OFFICE OF THE HISTORIC PRESERVATION COMMISSION

**RE: HISTORIC PRESERVATION COMMISSION APPLICATION NO. HPC 2020-052
BLOCK 265 LOT 7 ALSO KNOWN AS 48 Cookman Ave.**

Preliminary Review Notes

10. Doors

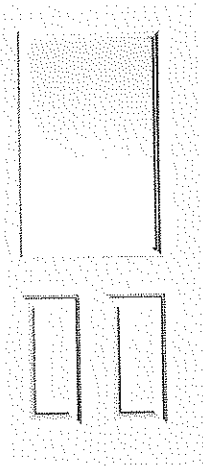
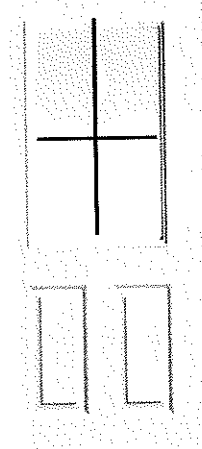
The existing doors are not original to the house. The two first-floor entrance doors and the second-floor porch doors will be replaced with half lite two panel flush ThermaTru doors painted white. The first-floor doors will have a single lite to match the style of the existing doors and the second-floor porch doors will have four lites to match the style of the existing doors. (See product list).

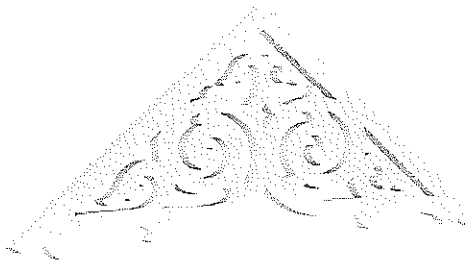
8. Ekena Millwork white Sellek Architectural Grade PVC Gingerbread Bracket will be applied around each column (See Product List) – Non-Compliant in PVC material – CPVC material would be acceptable as well as wood.

The gingerbread bracket will be changed to Ekena Millwork Athens Architectural Grade (cellular) PVC bracket so that it matches the pediment.

I spent an hour speaking to the manufacturers of Fypon, Azek, and Ekena brackets and pediments that could be used on our Cookman Ave house. They all told me that cPVC (chlorinated Polyvinyl Chloride) is only used in plumbing pipes. The reason is that this type of piping used for hot water must be able to withstand temperatures of up to 200 degrees. None of the companies make brackets out of cPVC. They do make cellular PVC. None of the companies call the material CPVC but rather, cellular PVC. The brackets that we propose using are made of cellular PVC. Ekena calls it Architectural grade PVC.

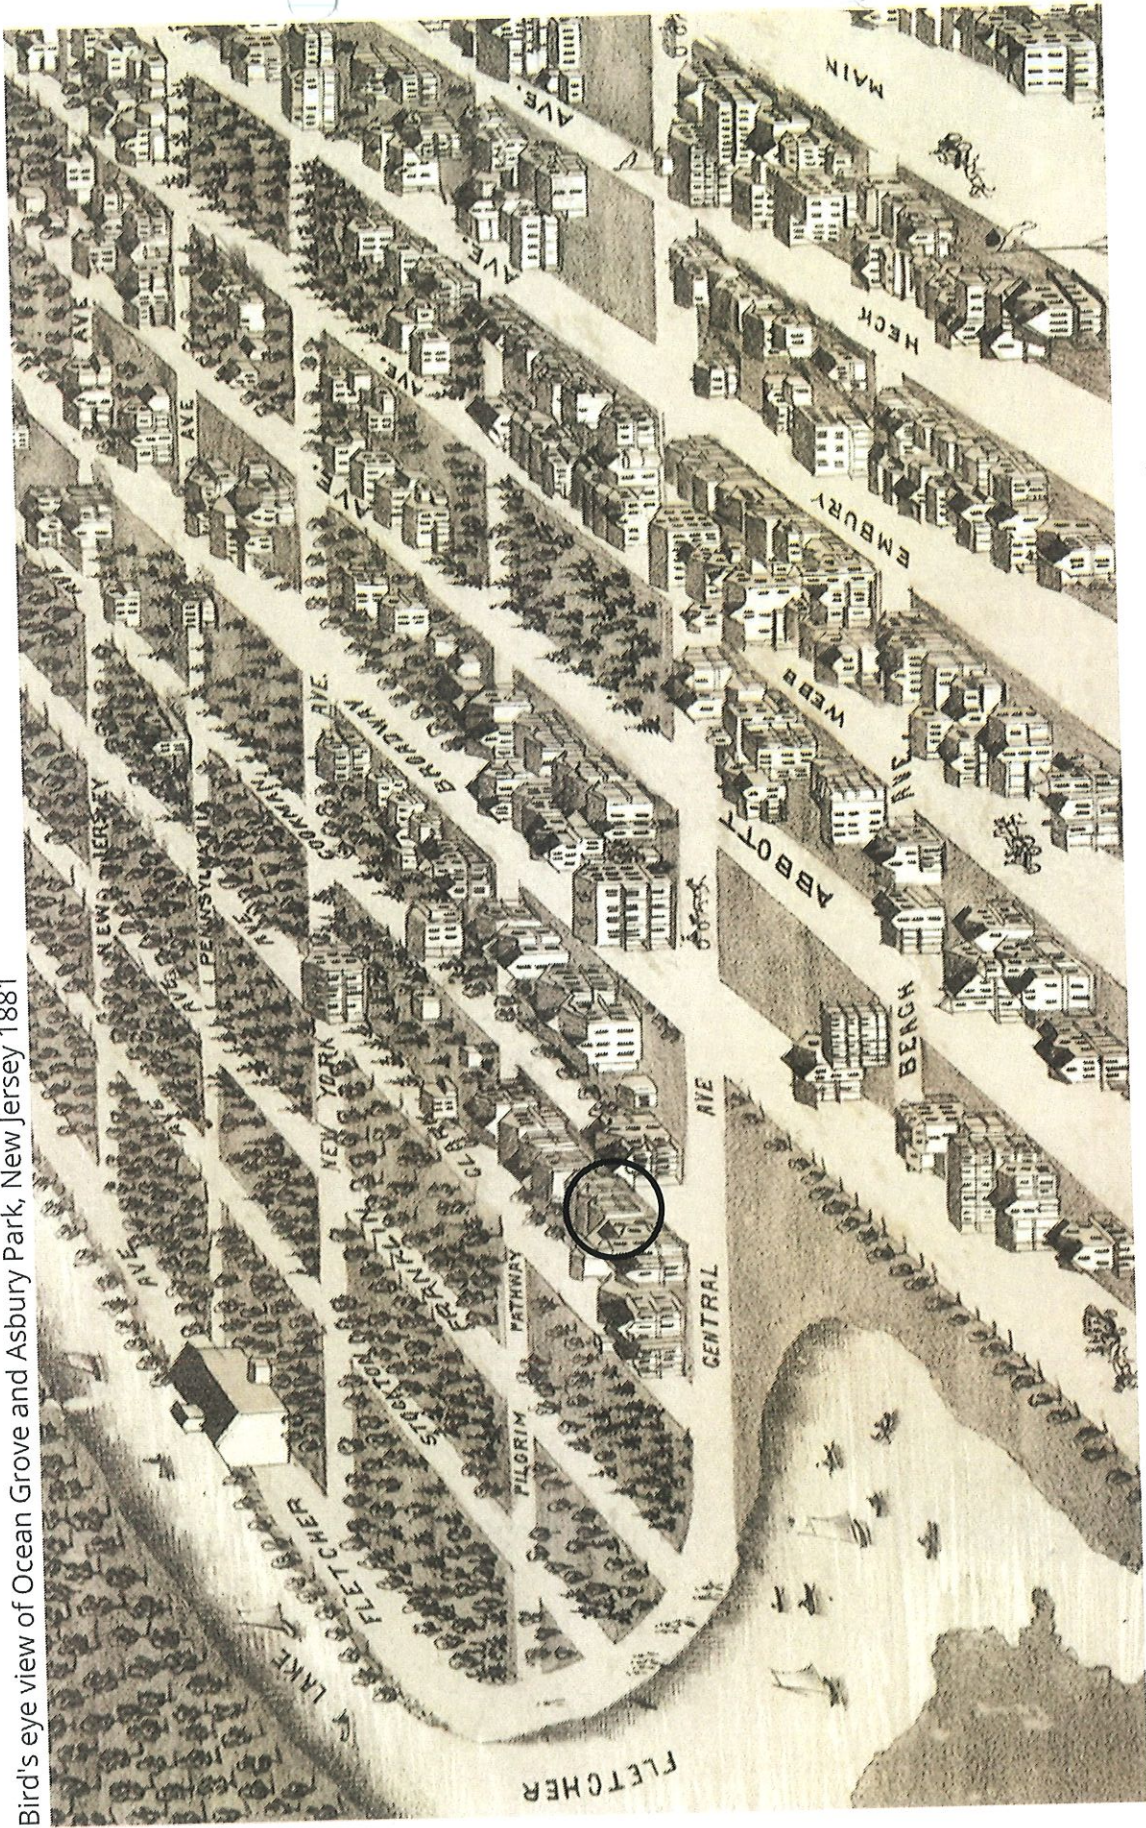
- **CONDITION OF APPROVAL:** The front overhang shall be reduced to comply with the 2' setback requirement.

Photo #4

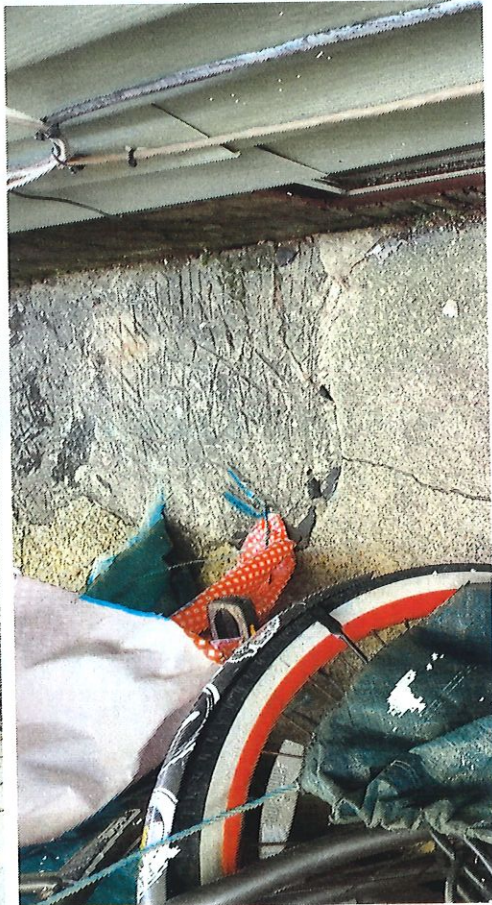
6. The original columns that had been repaired several times are now in a state of decay (see photos #3 & #4) have been clad with square aluminum covering for the 25 years that we have owned this house (See photo #5). An original column was exposed on the existing porch (See Photos #3, 4, 6, & 7). Historic exterior structural HB&G 6" columns (white) will be used on the first floor and HB&G 5" columns (white) will be used on the second floor. The new exterior columns to be used on the porches resemble the original columns. – A site visit is required to determine the condition of the existing columns. The condition cannot be determined by the photos themselves. As per Section IV, Subsection H of the Ocean Grove Historic Architectural Guidelines for Residential Structures, Item 1. p. 22 - The Applicant should "Retain, restore or replicate historic architectural elements and ornaments including corbelled parapets, decorative cornices, fascia brackets, porch and balcony railings featuring ornamental flat slat spindles or balusters, columns, covered porches, high pitched gables with gable ornament, roof ridge cresting, roof finials, turrets, towers, lattice porch panels, clay chimney pots, and ornamental newel post caps." The Applicant must provide documentation and justify the need to replace the columns in lieu of restoring/repairing the existing columns.

Please schedule a site visit so that an HPC representative can assess the exposed damaged porch posts.
